Project No. 21482114

**RESPONSE TO GEOTECHNICAL PEER REVIEW COMMENTS FROM GEMTEC
PROPOSED RESIDENTIAL DEVELOPMENT
3930 AND 3960 RIVERSIDE DRIVE, OTTAWA, ONTARIO**

A geotechnical peer review was completed by GEMTEC on behalf of the City of Ottawa and the relevant comments were provided in GEMTEC Letter no. 100008.025 – Rev0, dated Dec 7, 2023. The comments are noted below with response from WSP.

Title: Cross Section B-B
File Name: 21482114_Section B-B_1m higher_10_MG.gsz
Name: Seismic Undrained
Method: Morgenstern-Price
Horz Seismic Coef.: 0.15

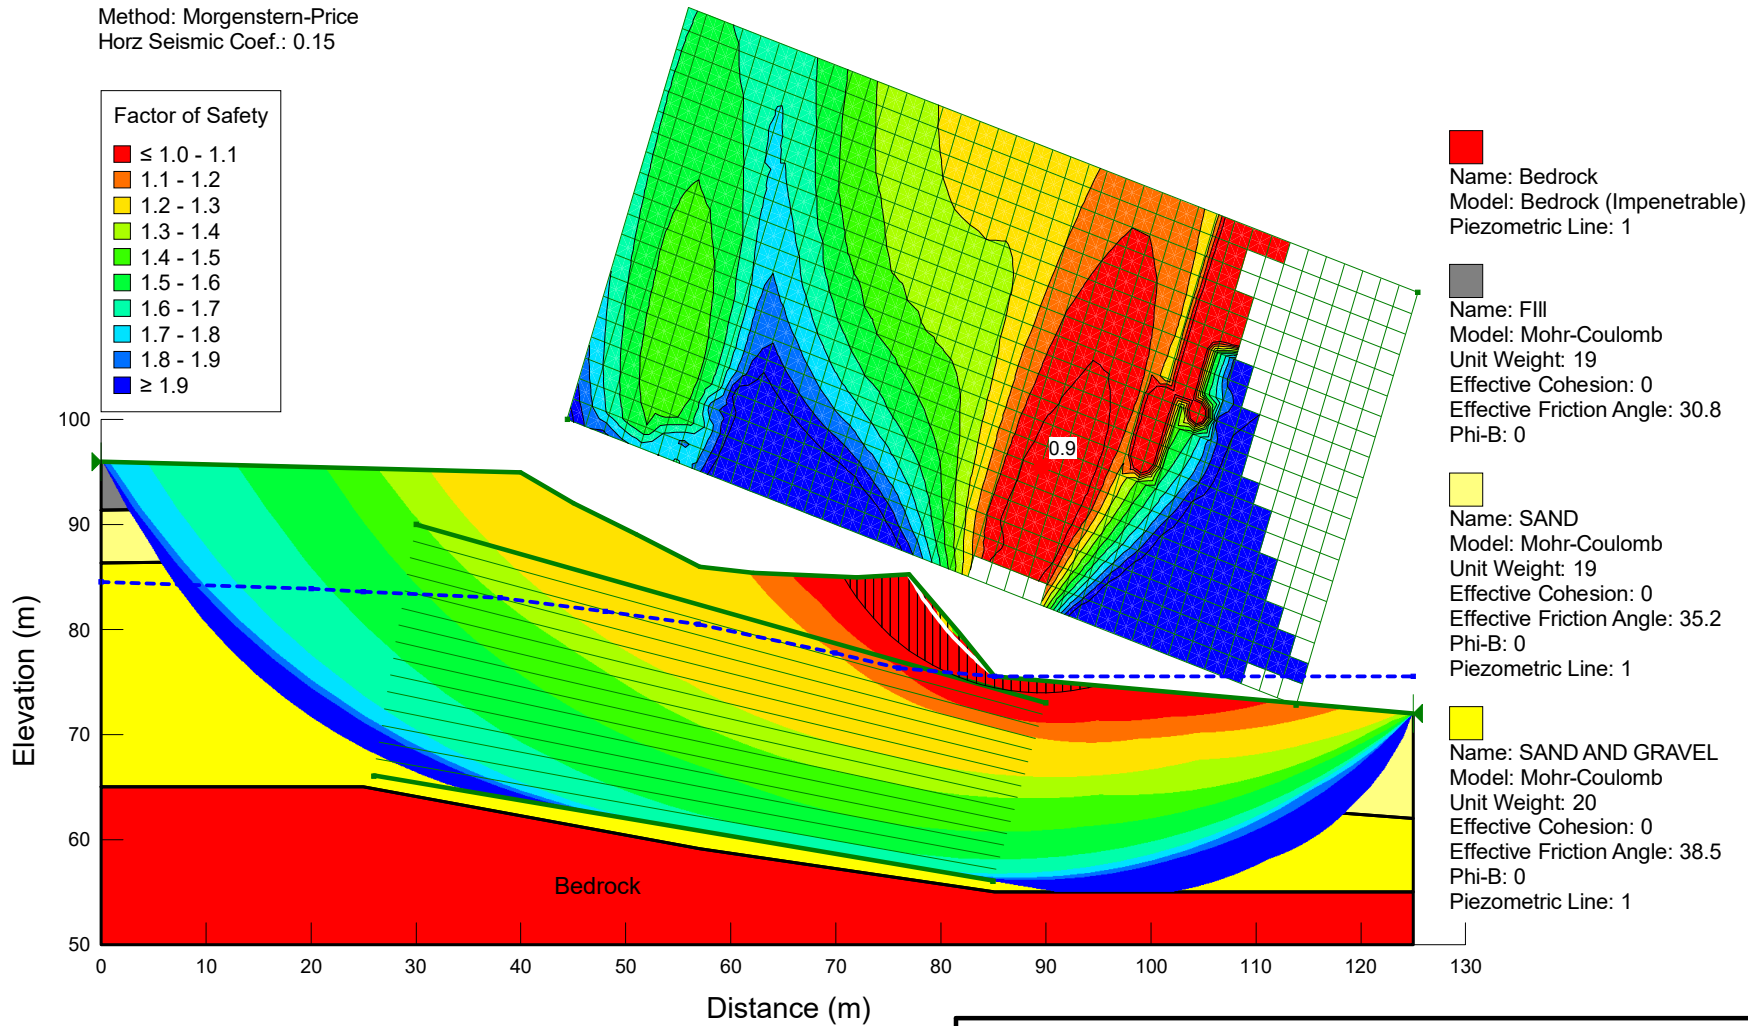
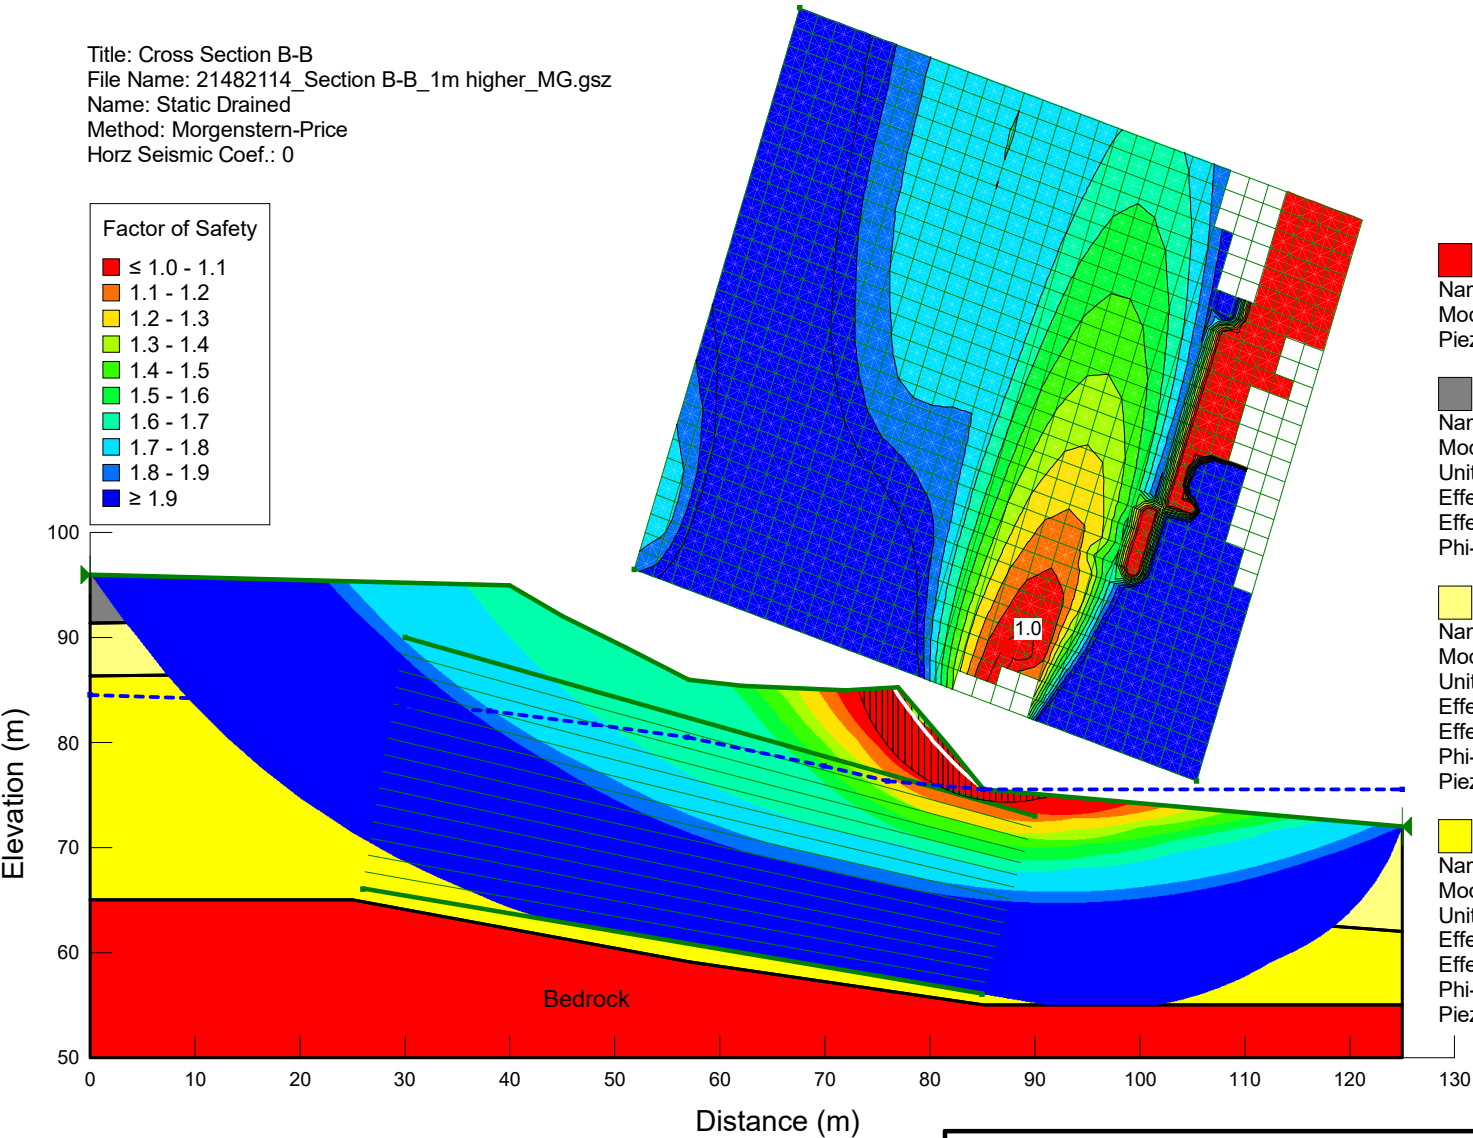
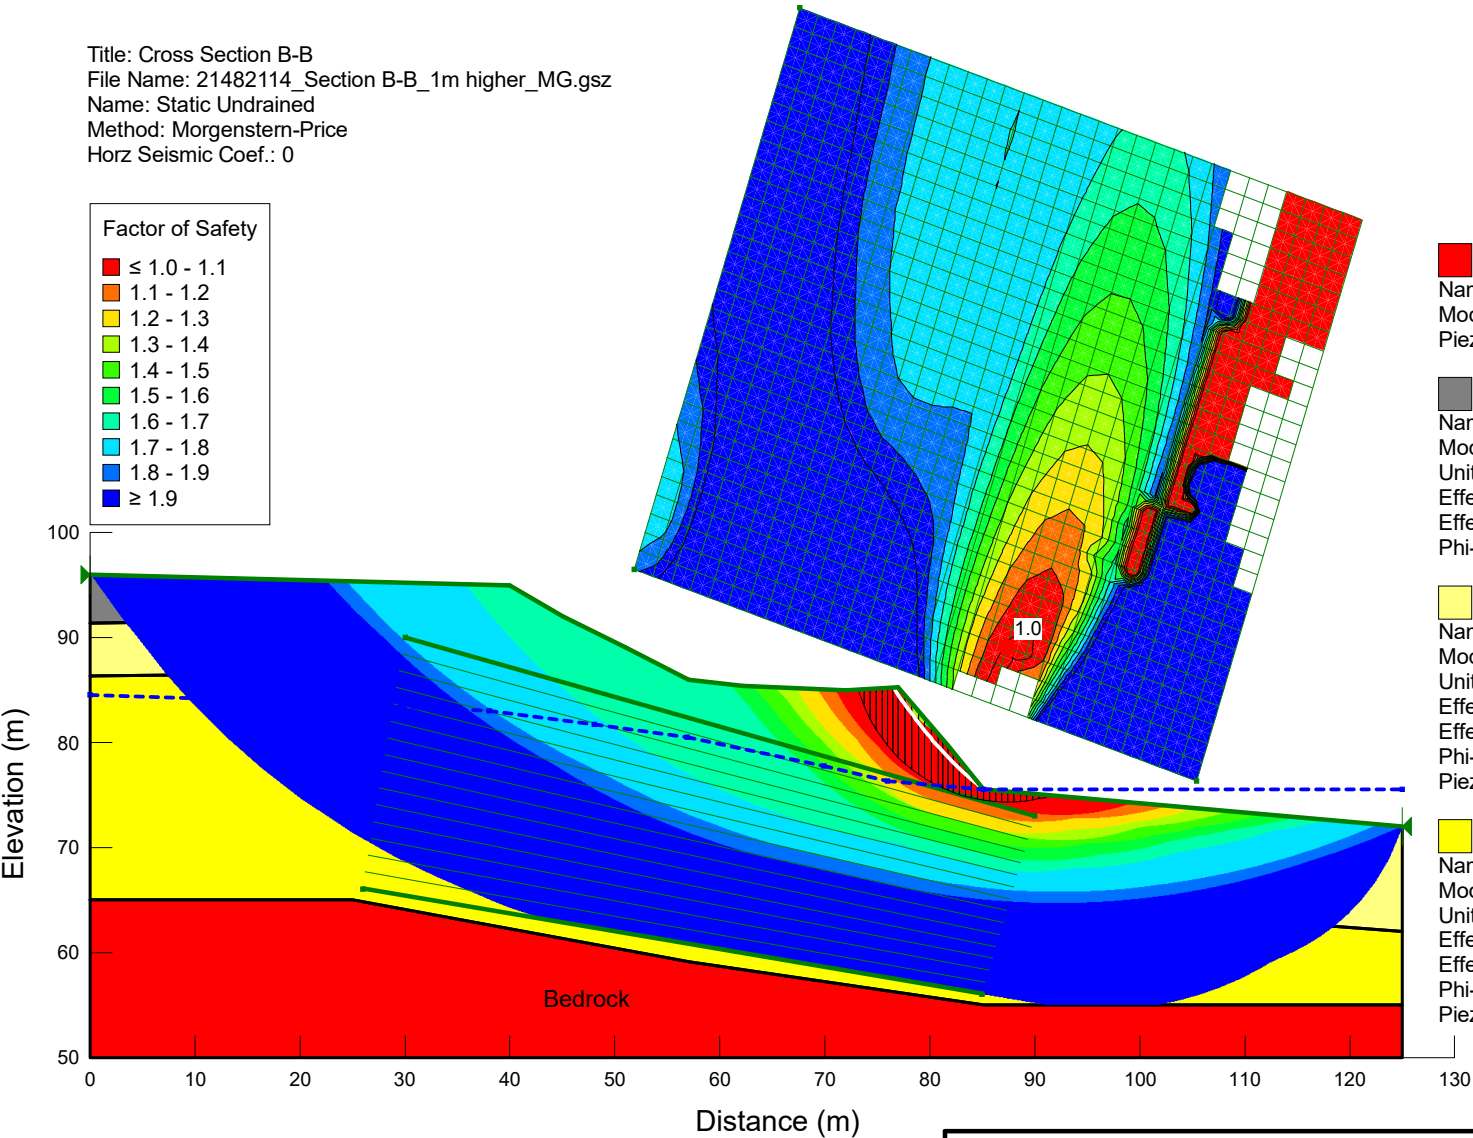
- 4) “The following comments are provided for the slope stability analysis carried out for Sections A-A', B-B', C-C', and D-D'. The safety map for the static and seismic analyses for the values of less than 1.5 and 1.1 respectively, extends past the upper edge of the point grid (for the slip circle centre), which may indicate there are slip circles with those factors of safety or less that extend horizontally farther than currently shown. This could potentially result in an increased stable slope allowance, and it is suggested that the model geometry be revised (by extending the point grid) to check the limits.”

- 5) “The groundwater level assumed in the static analyses for the South Area is at the base of the existing fill (i.e., at elevations of about 82 to 83 m) and is indicated to be based on the water levels measured in the various monitoring wells at the site. This would be Case 3 as outlined in the slope stability guidelines and may not be a realistic assumption. The fill materials above the native sands are not uniform in composition and contain cohesive layers and materials with high silt and clay contents that will tend to retain water and therefore it may not be reasonably conservative to assume the fill materials are fully drained as assumed in the slope stability analyses. The water levels summary in Section 4.1 of the report notes that: “In the South Area, the groundwater level was generally found to be between 12 to 16 m depth (i.e., between elevations of about 75 to 83 m), but as shallow as about 6 m (i.e., elevation of about 88 m).”

Response – *The models for the sections identified above were revised (by extending the point grid), no differences have been observed in the stable slope allowance.*

Response – *While the water level in the south area was recorded to be between elevations of 75.1 and 87.6 m (in monitoring wells as well as from CPT Dissipation testing), it was generally found to be below elevation of 79 m. Only one single borehole location had a higher water level of 87.6. We therefore feel that the original assumptions regarding groundwater level are reasonable assumptions for the overall groundwater depth in the area of interest. Nonetheless, as a precautionary measure and an additional check, the slope stability models for these four sections were revised to take into account for the possibility of a higher groundwater level in South Area by adjusting the piezometric line in the analysis upward in the east side of the site (where the single high level was recorded). This adjustment results in a very minor change to the slope stability (well within the margin of error of the data and assumptions which go into the analysis). The change is of sufficiently small magnitude as to make no meaningful difference to recommended stable slope allowance, and therefore we feel that the originally recommended setbacks may be maintained. The results of the revised slope stability analysis are attached to this memorandum.*
